North Hertfordshire District Council

Building Conservation comments

File Ref: 25/00509/FPH & 25/00510/LBC

Subject: Renovation and conversion of existing barn into habitable accommodation, to include insertion of windows to front and side elevations, insertion of two rooflights in rear elevation and repair or replace existing cart doors. Installation of mezzanine floor, and erection of single storey glazed extension to link to main dwelling, following part demolition of existing side store.

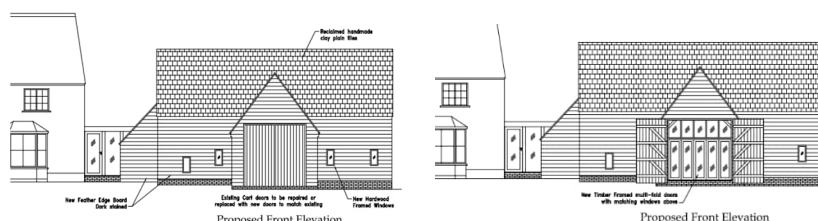
4.1 Below is a comparison between the 2011 scheme and that now proposed indicating the roof lights removed from the front elevation and cart doors included.

Size of glazed panels in east gable

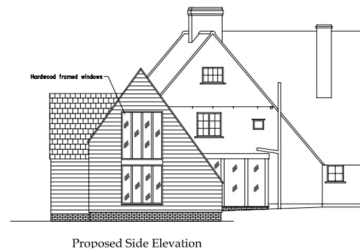
In terms of proportions, one might normally expect first floor glazing to cover a smaller area than that at ground floor. On this occasion, the first floor glazing in the east gable end is taller than that below the mezzanine and the amount of glazing proposed is commensurate with a large cart door opening which would not have existed on this part of the building. Whilst I have no objection in principle to a significant amount of glazing in the east gable (bearing in mind that this gable is relatively devoid of internal framing), I suggest that some weatherboarding is introduced at first floor mezzanine level to a height of let's say one metre so that the first-floor glazing is less dominant. This suggestion will also have the additional benefit of concealing the mezzanine level.

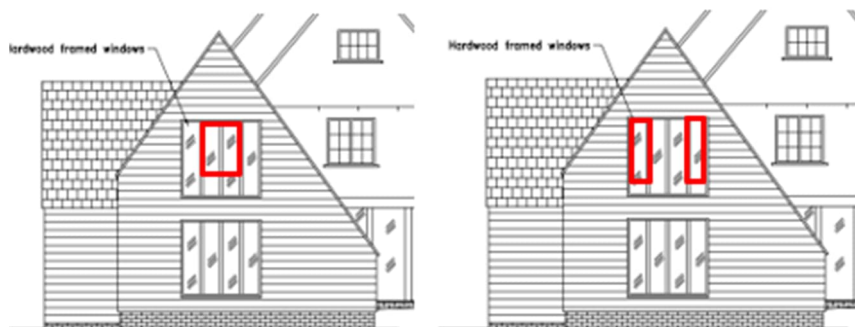
- 4.3 Whilst noting the following in the submitted DHS, I make further comment regarding the treatment of the gable end:

Even though the timbers at the right hand gable end are quite modern, the new window has still been designed to fit within the existing timbers with very little alteration required (see left).

The new windows & doors to the Front gable fit to the existing door opening. All New windows are designed to fit between existing vertical struts. The Roof will consist of entirely new rafters, the roof lights will not affect any original timbers at all

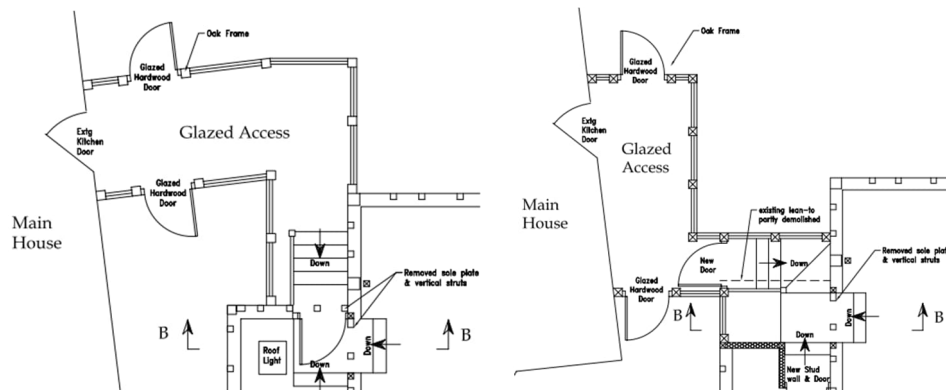
- 4.4 The 'quite modern' framing in the right-hand gable end is unconventional in that there is no central main post and no continuous tie chord at the height of the front wall plate. Had these existed it would have been an opportunity to express this framing internally. Although the DHS describes what is now shown as a 'reasonable compromise' there is opportunity to go slightly further in reducing glazing at first floor. Below are two possible options that would, in my opinion, be considered improvements. The left-hand version could be designed as a pair of casements whilst weatherboarding could be introduced between the glazing in the right-hand image.
